# ADDENDUM No. 1

RFP No. 22-50

## Russell Street Improvements

SHEET No. 8A OF 22

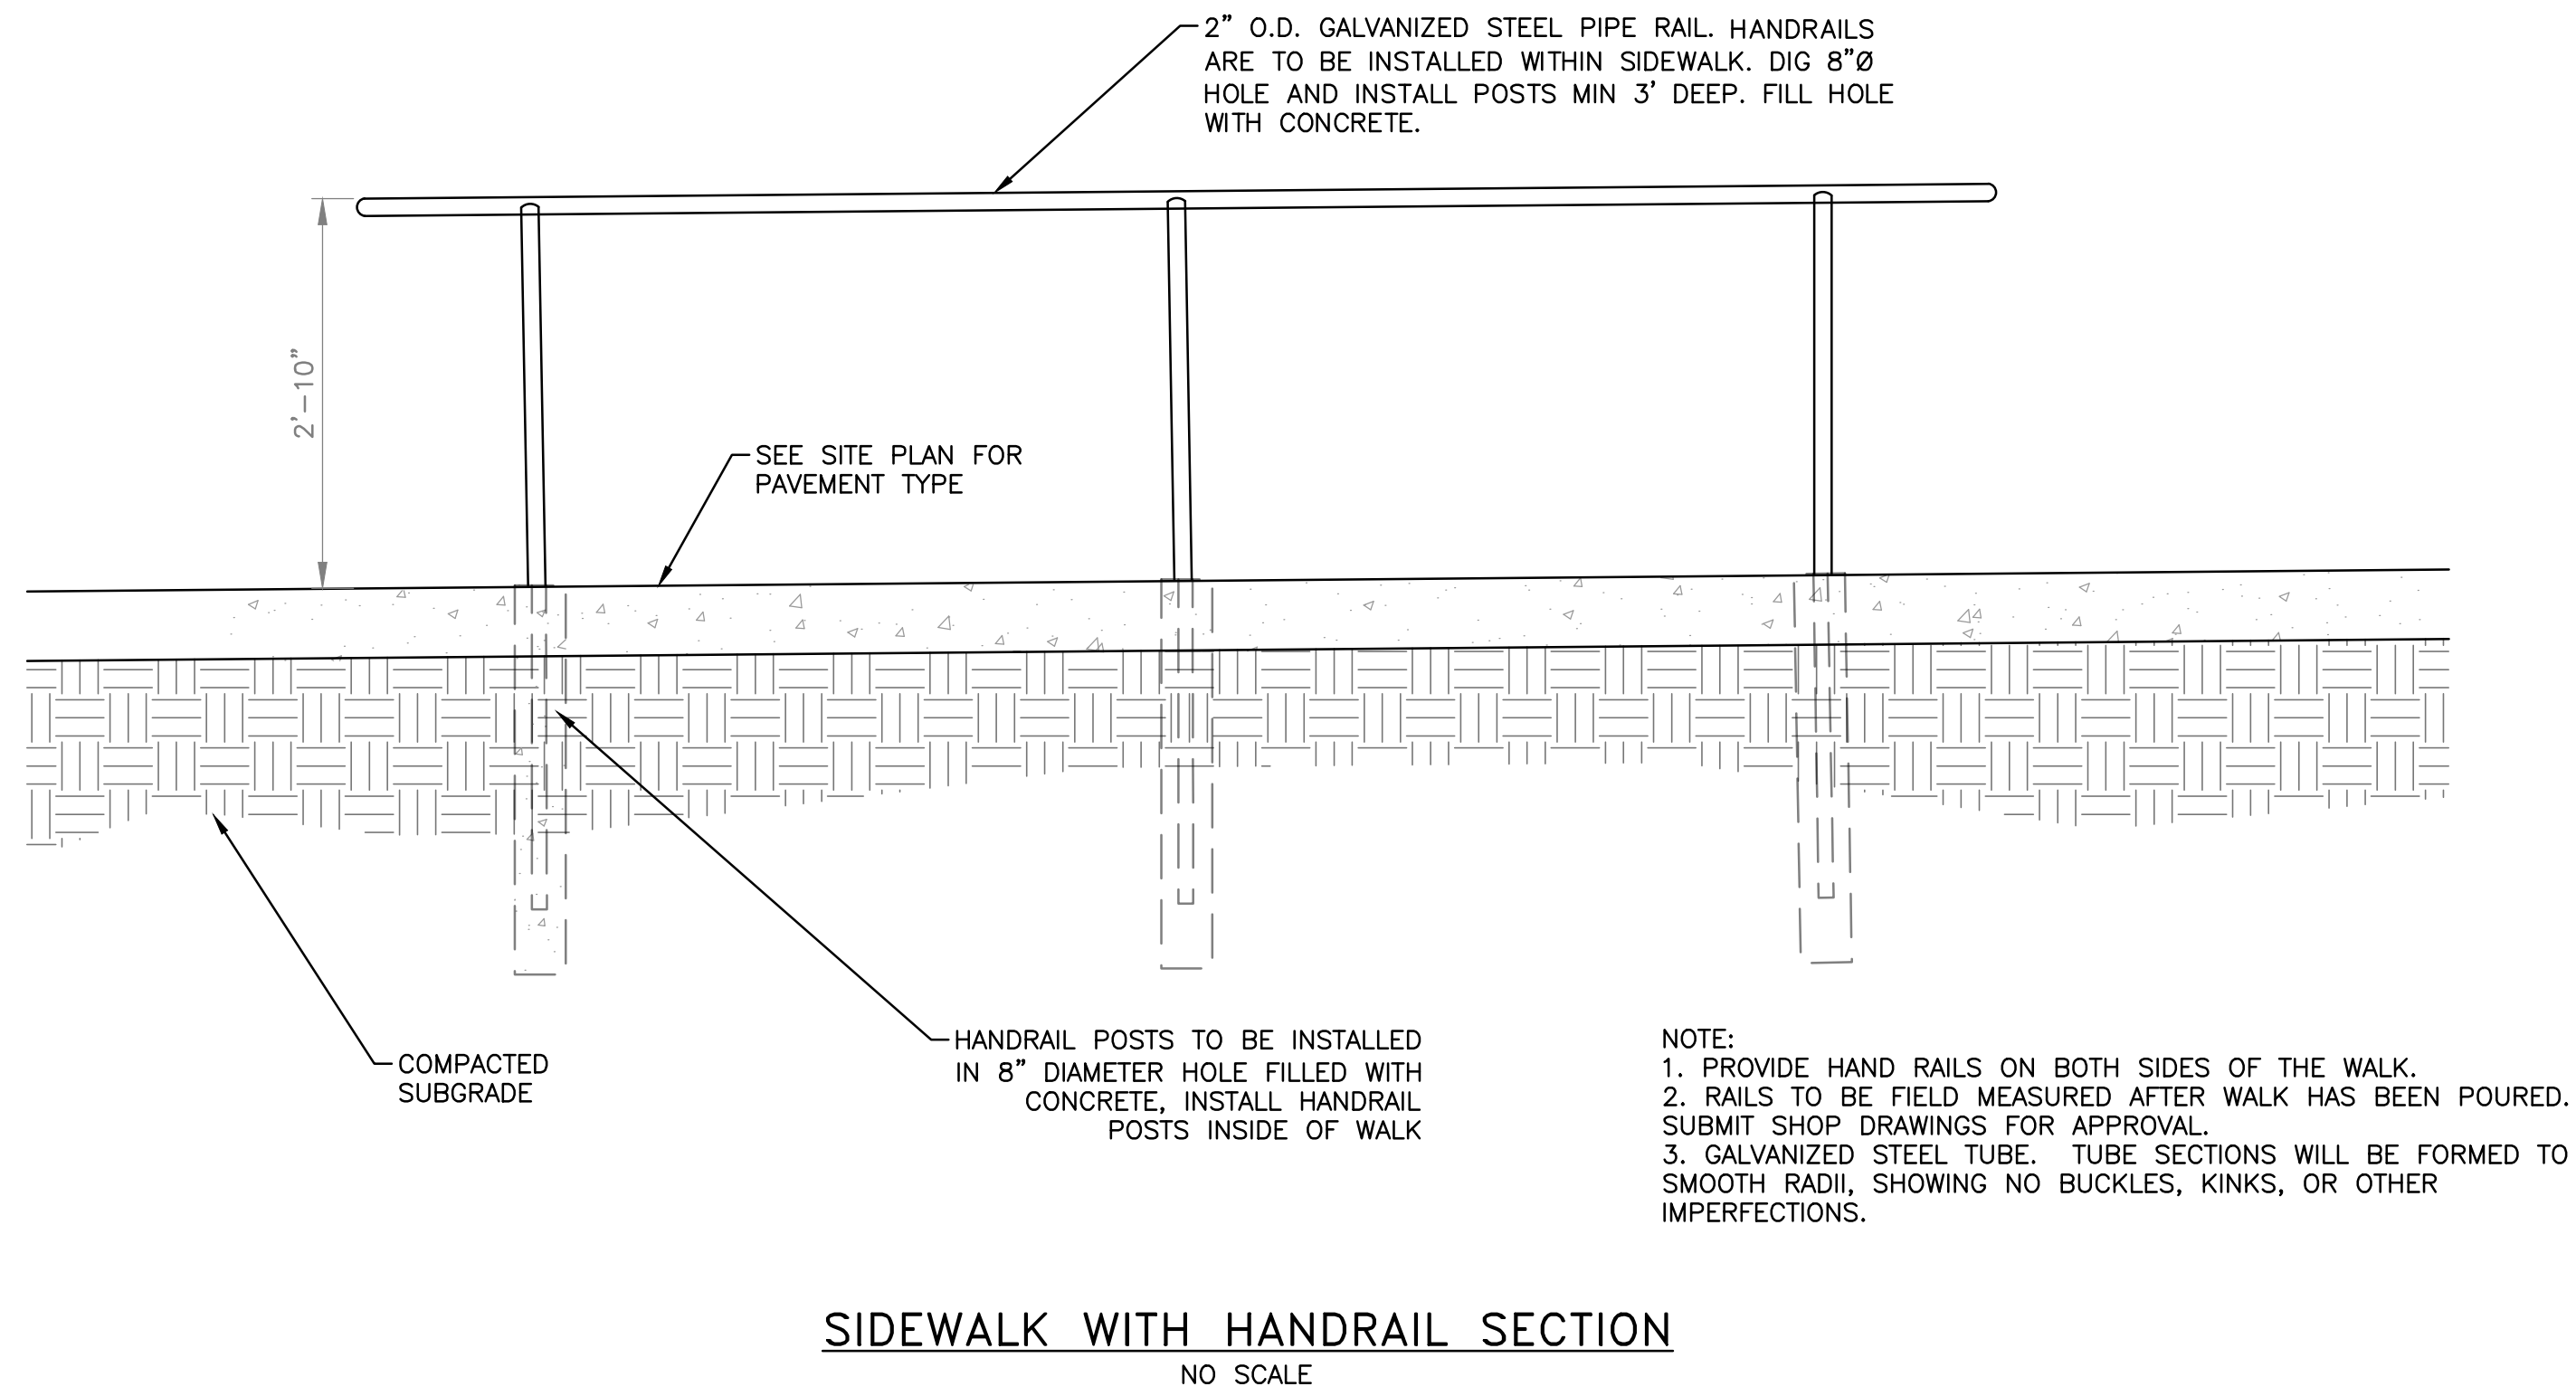
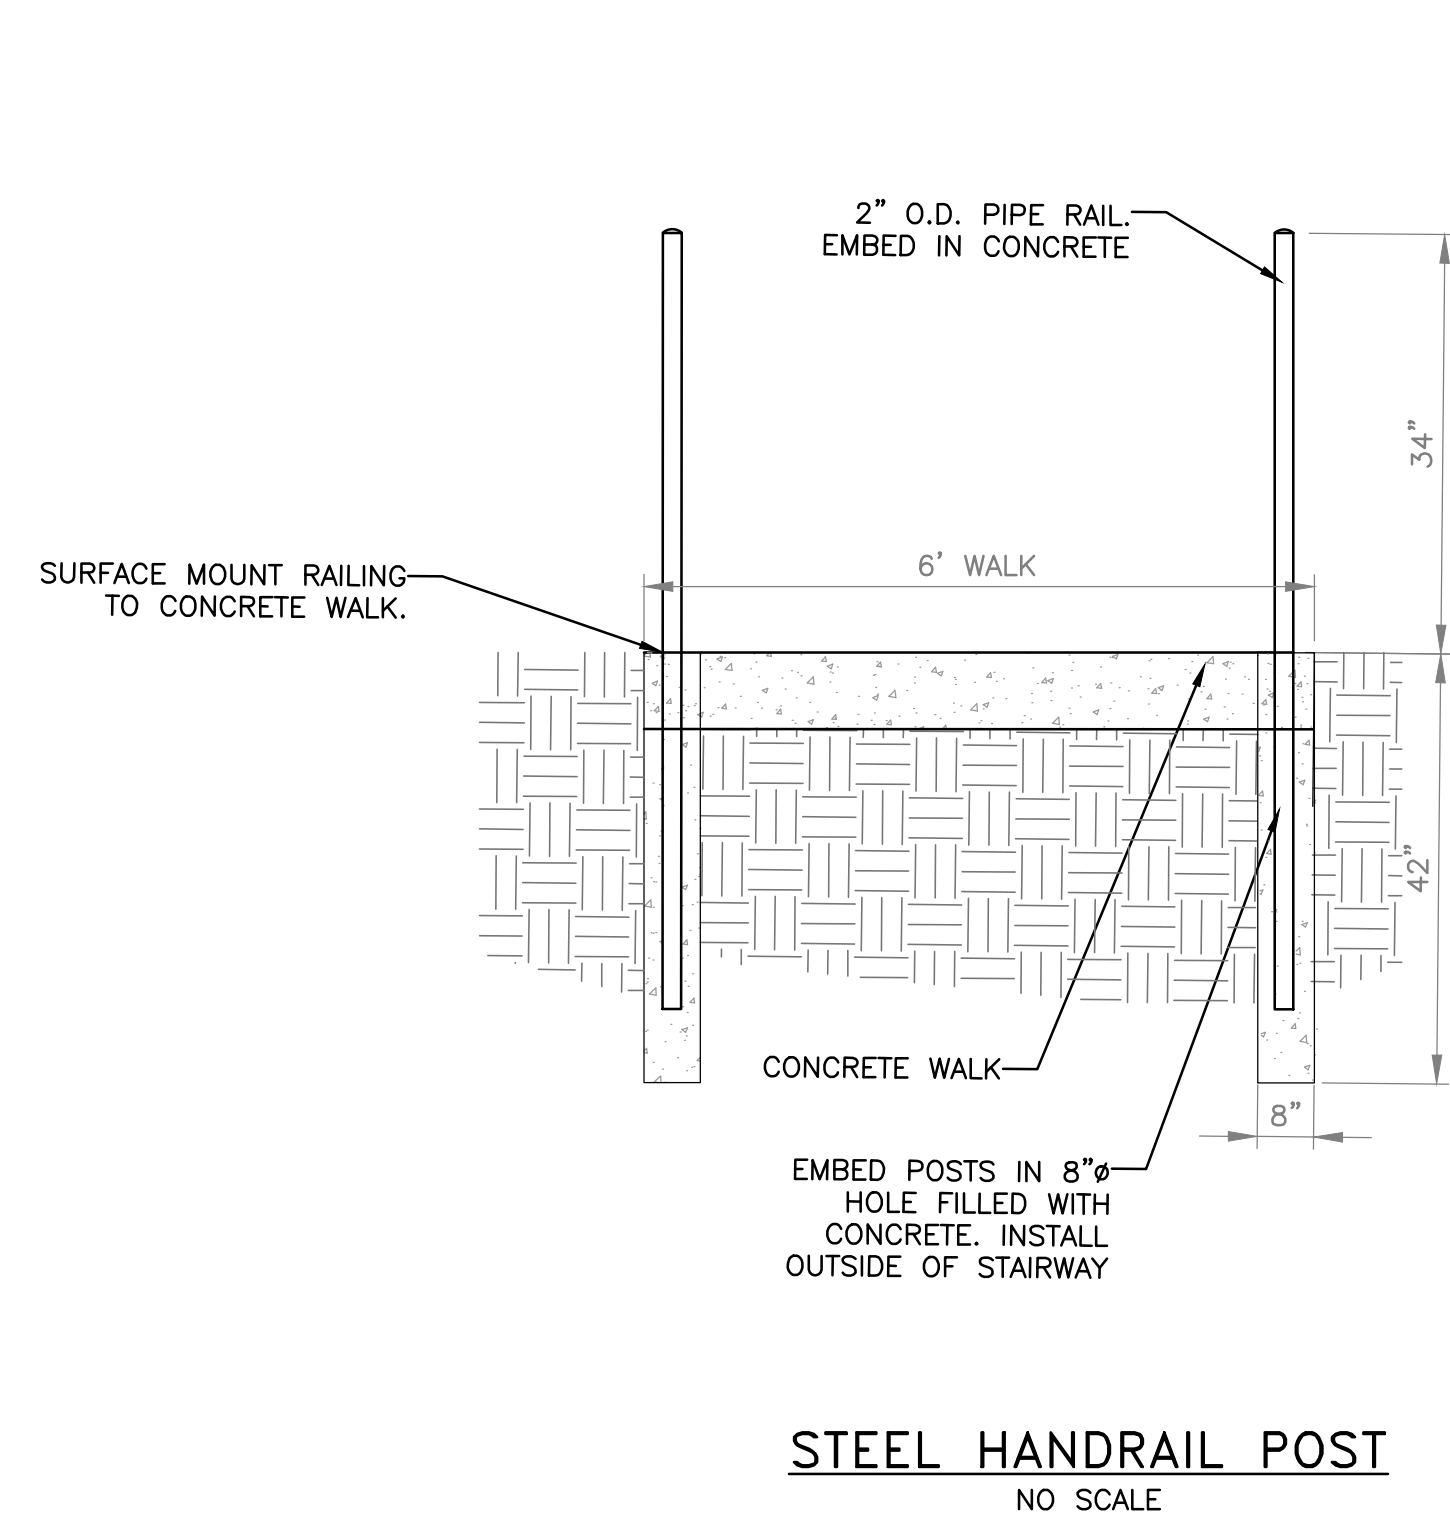
Section/Page(s)	Change
Pages 2-4	The Bid Form has been amended to reflect the modifications of this Addendum No. 1. Item number 254, Handrail, Lump Sum has been added.
Pages 5-6 + Plans	The project is adding handrail to the north side ramps to Maple Meadows as shown in the attached drawings (Plan Sheet 8A, Plan Sheet 11), detailed specification dated 06-02-2022, and Bid Form.
Plans Only	The controlled stormwater outlet structure detail has been corrected to show the proper Fluidic Cone outlet size of 9-inches (Plan Sheet 19, dated 06-02-2022). The Fluidic Cone model remains the same (FC-9).

NOTE:  
 1. PROVIDE HAND RAILS ON BOTH SIDES OF THE WALK.  
 2. RAILS TO BE FIELD MEASURED AFTER WALK HAS BEEN POURED. SUBMIT SHOP DRAWINGS FOR APPROVAL.  
 3. GALVANIZED STEEL TUBE. TUBE SECTIONS WILL BE FORMED TO SMOOTH RADII, SHOWING NO BUCKLES, KINKS, OR OTHER IMPERFECTIONS.

Provide pipe railing system with maximum 8-foot maximum post spacing and minimum 42-inch railing height to top rail. Top rail of handrailing system shall be 34-inches high above the sidewalk.

Provide removable pipe railings with close-fitting sleeves set in concrete where indicated on the Plans. Sleeves shall be 1-inch less in length than thickness of concrete.
